# Access Compliance Report

## Public Rights-of-Way

### (Curb Ramps)

Intersection ID: 31738	Main Street: LEAF_PLUM_DR	Cross Street: SAWLEAF_CT	Location: NW
ADA ID: 16C61469DF86	Ramp Type: PerpDiag	Initial Pass/Fail: Fail	Overall Compliance: No
		Severity Score: 12.5

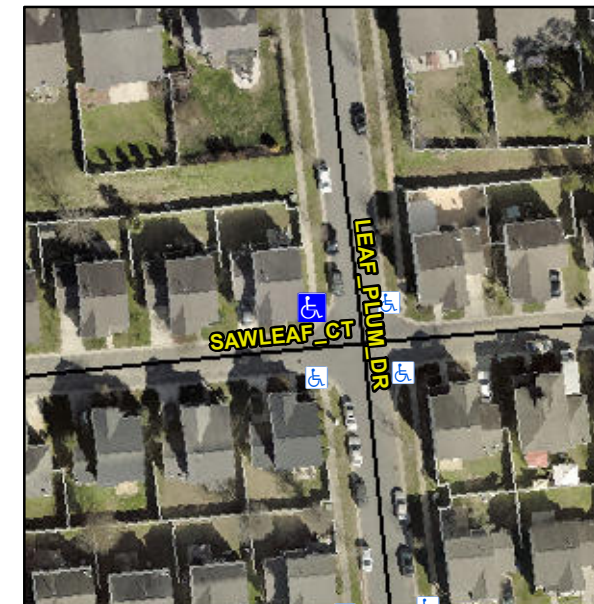
**Not Found, R304.2.2**

Compliance	Description	Data	Compliance	Description	Data
N/A	Ramp Length (in)	67.0	No	Ramp Slope (%)	9.3
Yes	Ramp Width (in)	48.0	Yes	Ramp XSlope (%)	1.9
N/A	Flare Type LT	N/A	N/A	Flare Type RT	N/A
N/A	Flare Slope LT (%)	N/A	N/A	Flare Slope RT (%)	N/A
N/A	Flare Traversable LT?	N/A	N/A	Flare Traversable RT?	N/A
N/A	Landing Length (in)	N/A	N/A	DWS Provided?	N/A
N/A	Landing Width (in)	N/A	N/A	DWS Contrast?	N/A
N/A	Landing Slope (%)	N/A	N/A	DWS Length (in)	N/A
N/A	Landing X Slope (%)	N/A	N/A	DWS Full Width?	N/A
N/A	Landing Curb? (Y/N)	N/A	N/A	DWS Offset (in)	N/A
N/A	Shared Landing?	N/A			
N/A	Gutter Ponding?	N/A	N/A	Gutter Slope (%)	N/A
N/A	Gutter Lip Ht (in)	0.5	N/A	Gutter X Slope (%)	N/A
N/A	Painted X Walk1?	No	N/A	Painted X Walk2?	No
	X Walk 1 Direction	To S		X Walk 2 Direction	To E
N/A	X Walk 1 Width (in)	N/A	N/A	X Walk 2 Width (in)	N/A
	X Walk 1 Slope (%)	3.5		X Walk 2 Slope (%)	2.5
	X Walk 1 X Slope (%)	1.3		X Walk 2 X Slope (%)	2.8

**Remove & Replace Curb Ramp With Two New Directional Ramps or Equivalent.**
